ADDENDUM 4 SS-2201 SANITARY SEWER REHABILITATION PROJECT (PHASE 1) CIP PROJECT NO. SS-2201

November 2, 2023

CITY OF PINOLE SANITARY SEWER REHABILITATION PROJECT (PHASE 1) CONSTRUCTION DETAILS

3 CCCSD STD DETAIL 20-01
- NOT TO SCALE

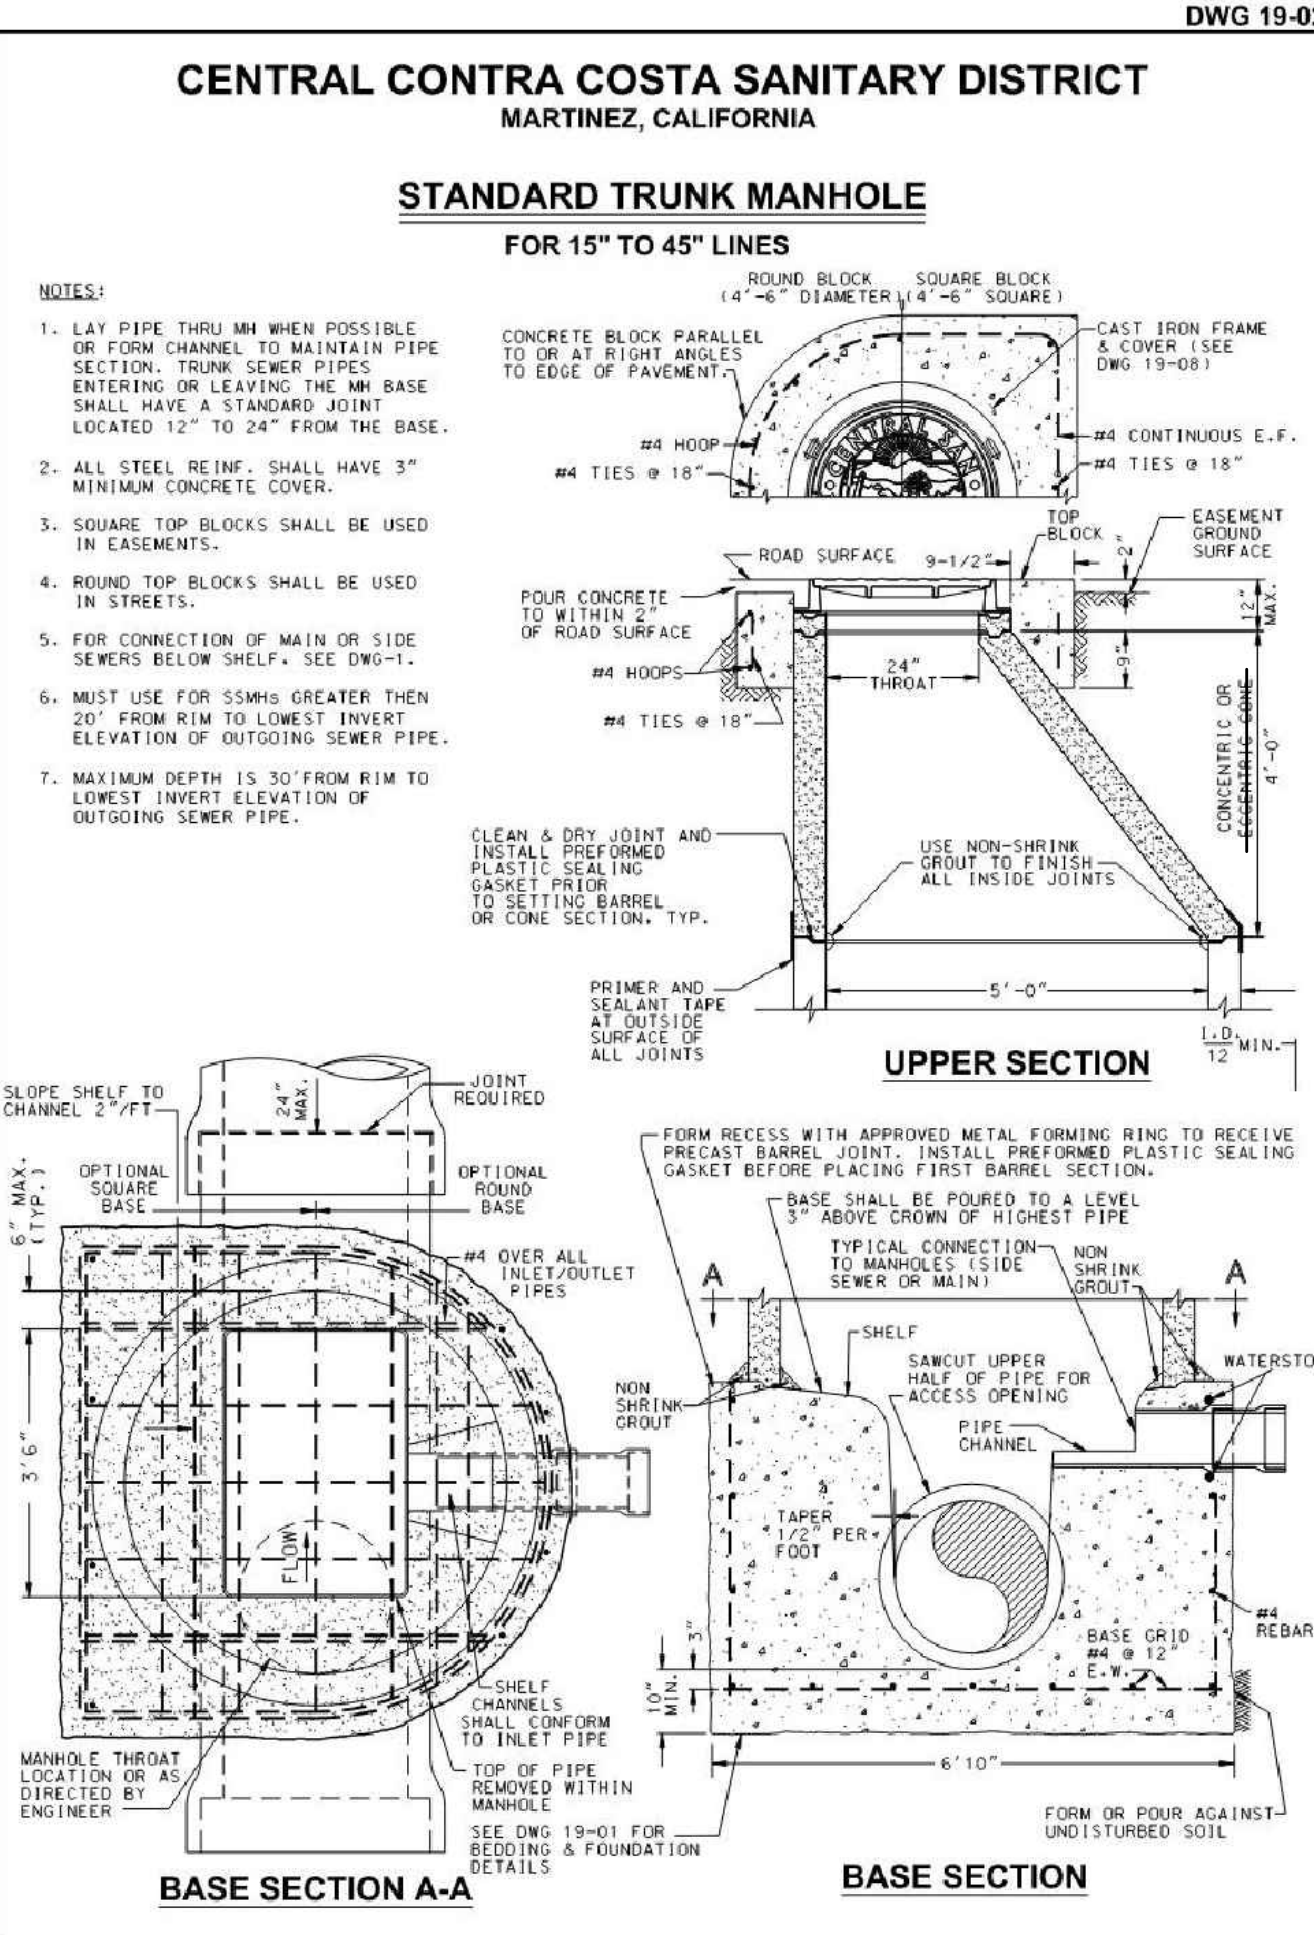
10/30/23	DCW REVISED DETAIL 3, ADDED DETAIL 5	DESCRIPTION
11/2/23	DCW REVISED DETAIL 5	
NO.	DATE	BY

5 HMA SURFACE RESTORATION
- NOT TO SCALE

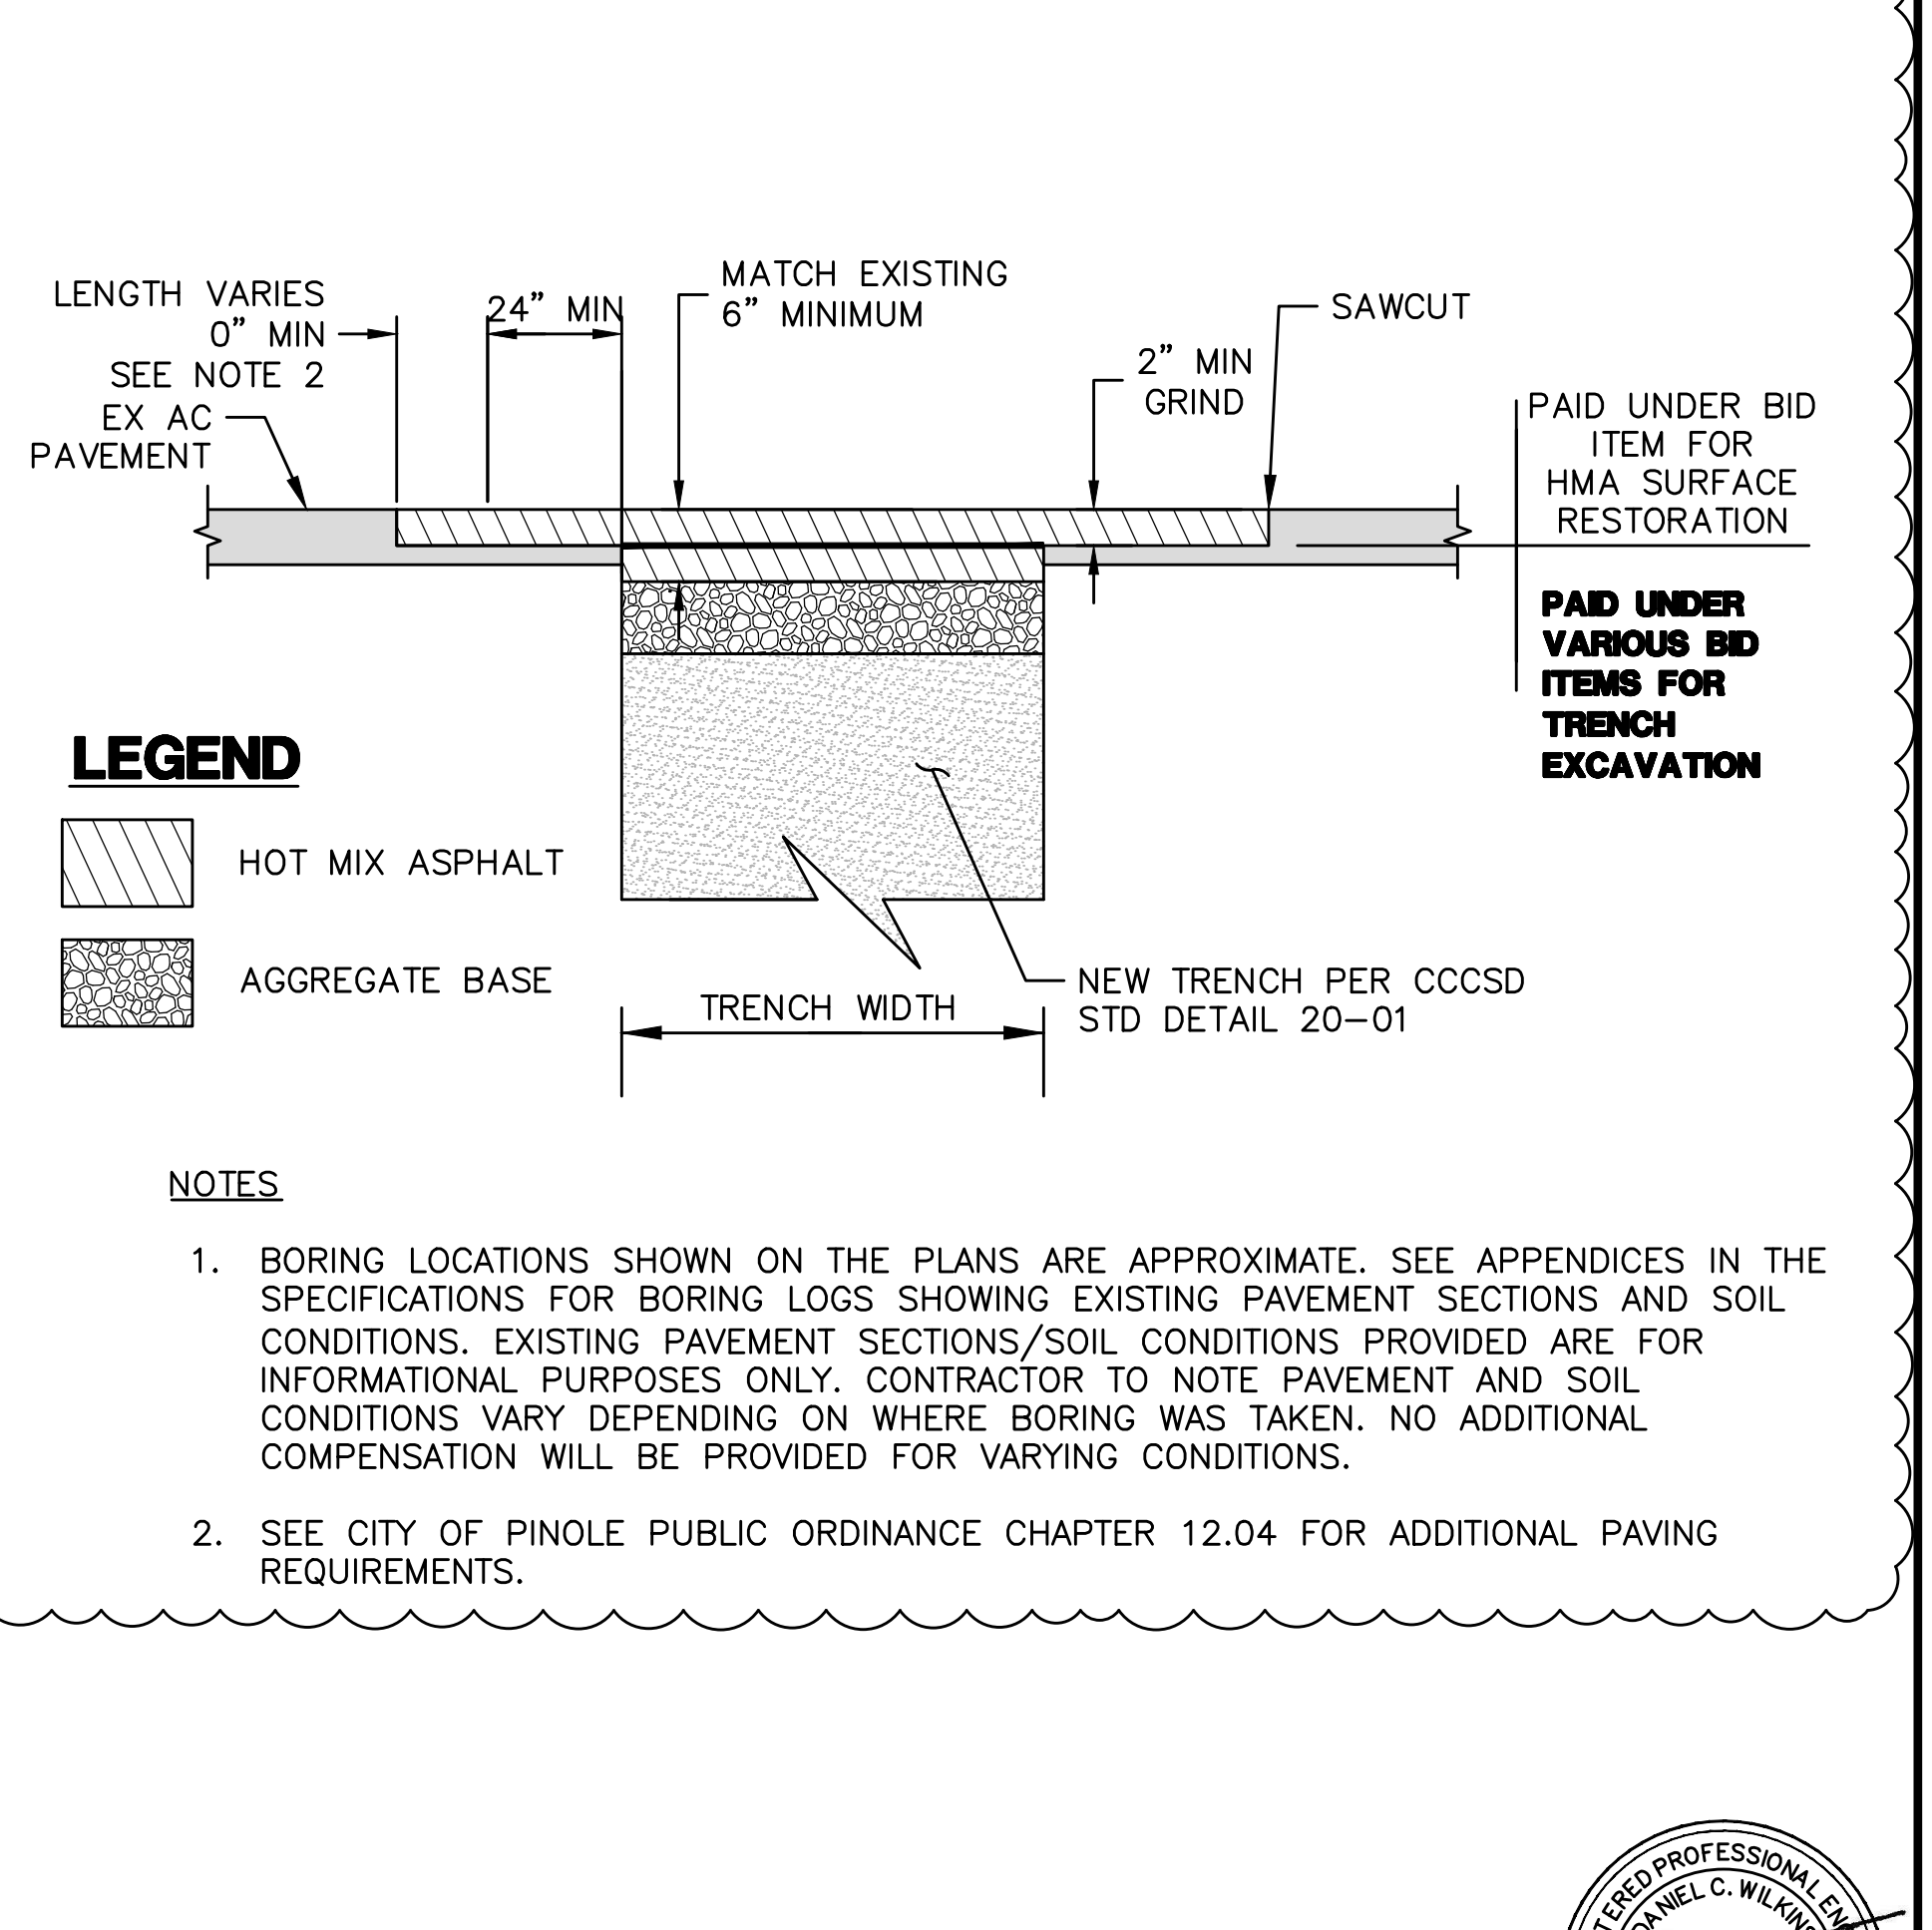
Q15. Trench Paving Section. Would you clarify the width of the 6" minimum section. Is it the intent of the City to require the 6" min. full depth AC to extend 24" minimum on each side of the trench as shown on detail 5/D-01; or just the 2" grind and pave section?

Answer: Please see Detail 5 of Sheet D-01 as revised in this Addendum 4.
